GMN ERR  
Charges 6 and 7  
Jay Benesch

# Charge Items

- 6. Is the beam delivery affected by the running configuration of BigBite and SBS? If yes, have the fringe field effects been properly mitigated?
- 7. Are the beam commissioning procedures and machine protection systems sufficiently defined for this stage?

# SBS assembly bottom view

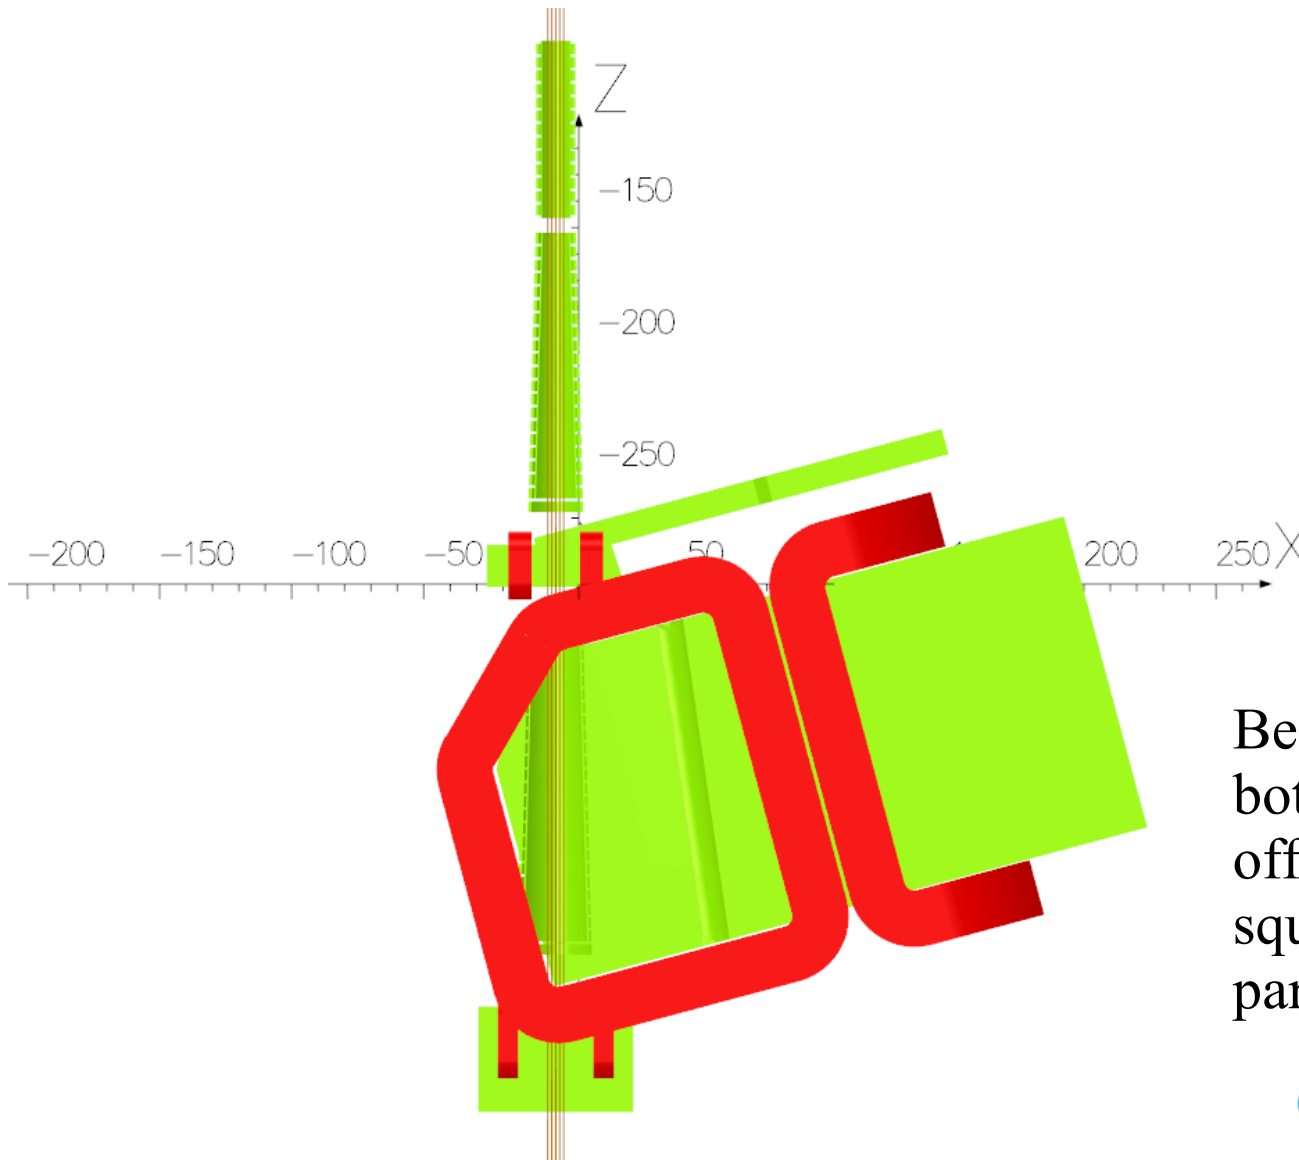
Beam propagates top to bottom; target at  $Z = 0$  off top of page. 6 cm square array of 4.5 GeV particles shown

# 11 GeV particle array

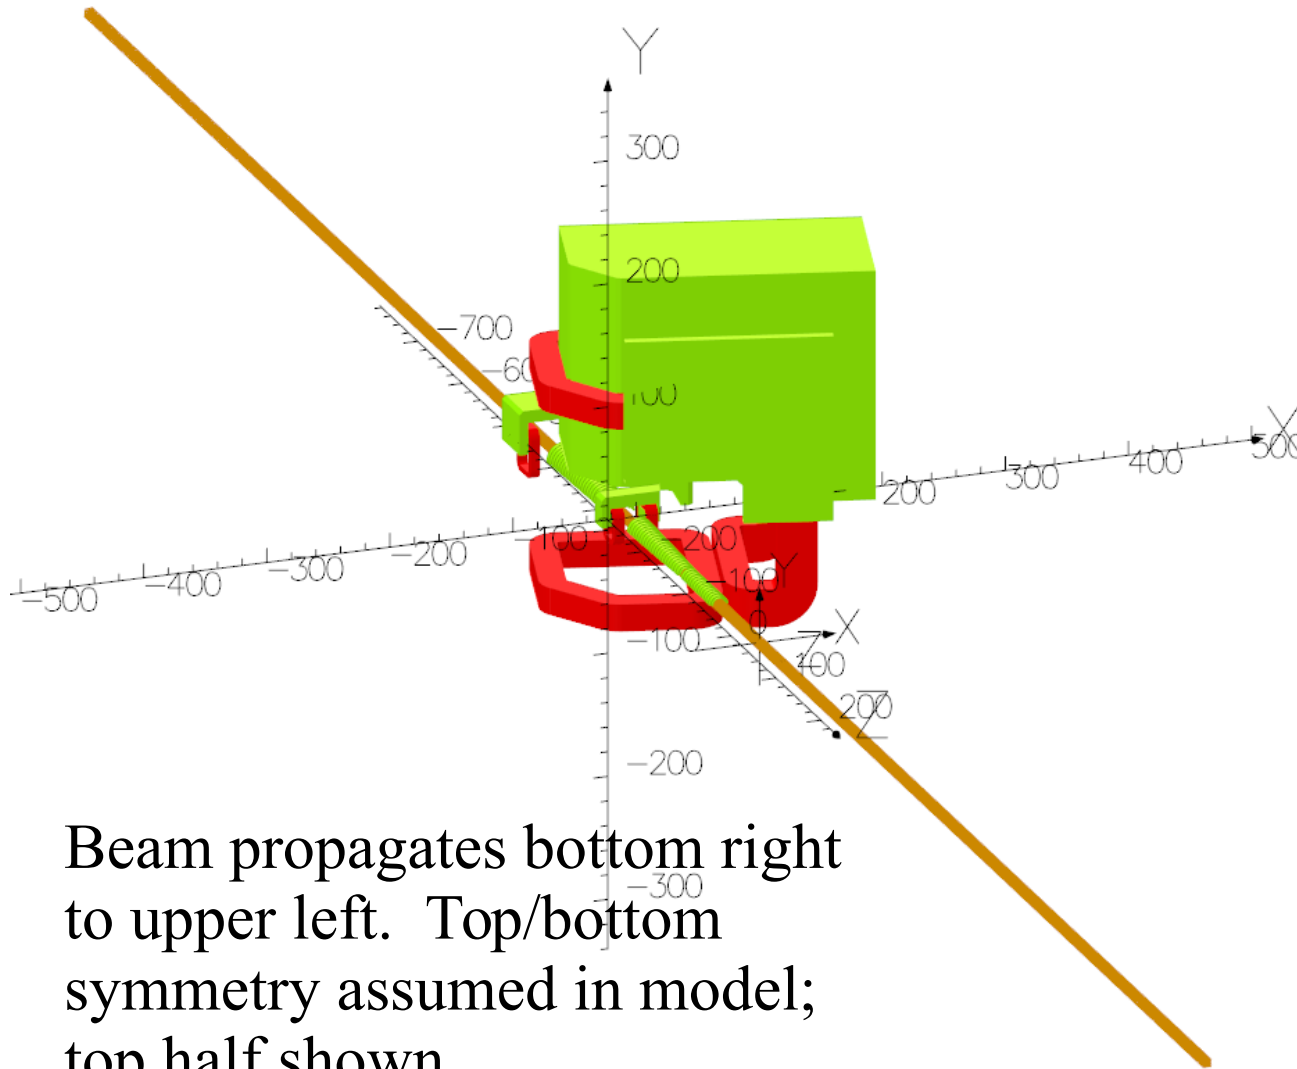
Beam propagates bottom right to upper left. Top/bottom symmetry assumed in model; top half shown.

# 4.48 GeV particle array

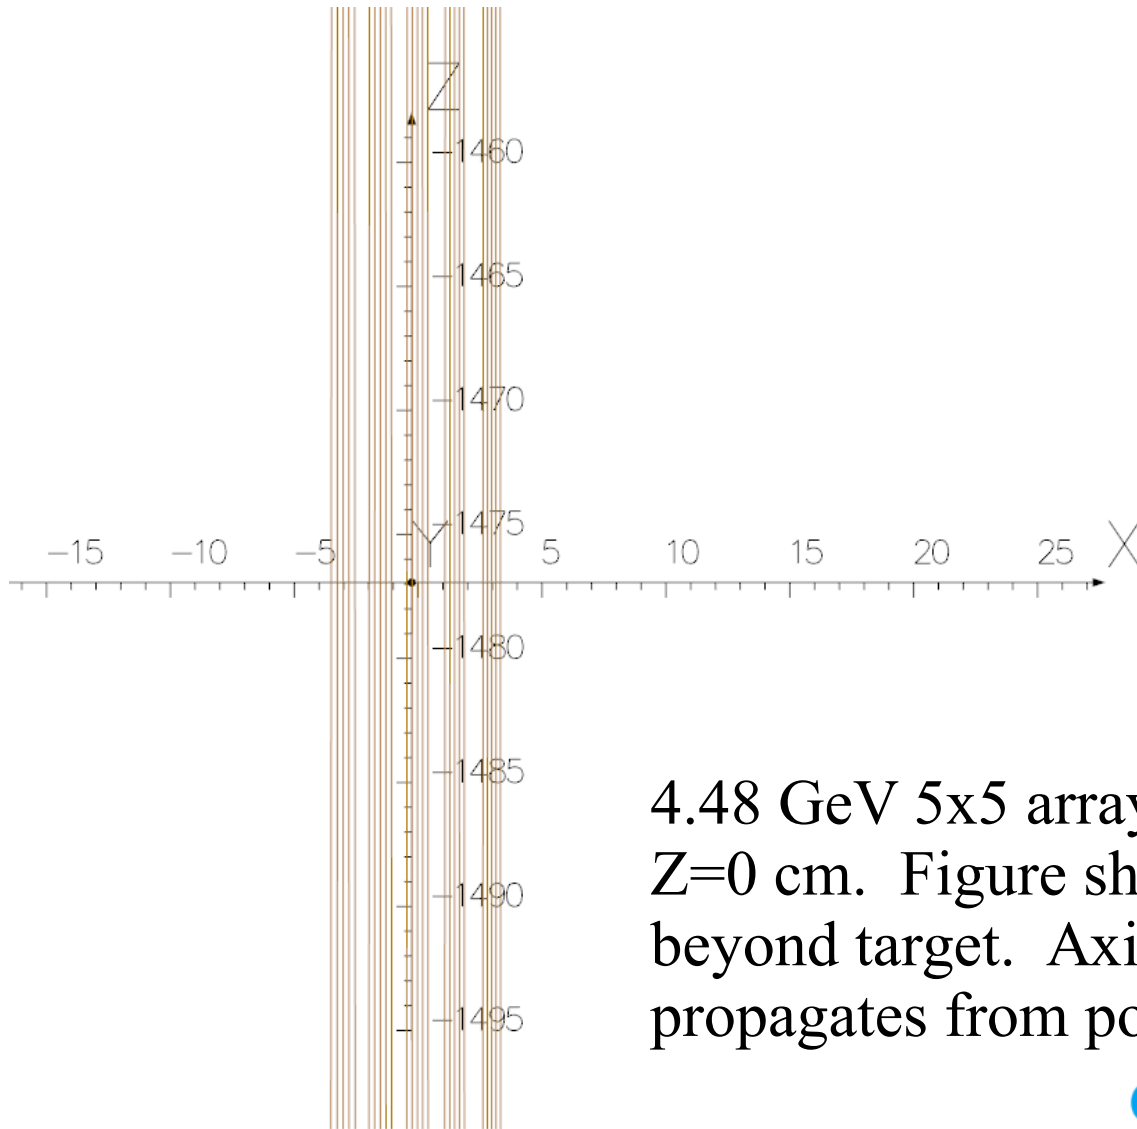
4.48 GeV 5x5 array, 6 cm square, launched at Z=0 cm. Figure shows X deflections 1500 cm beyond target. Axis scales cm. Beam propagates from positive to negative Z.
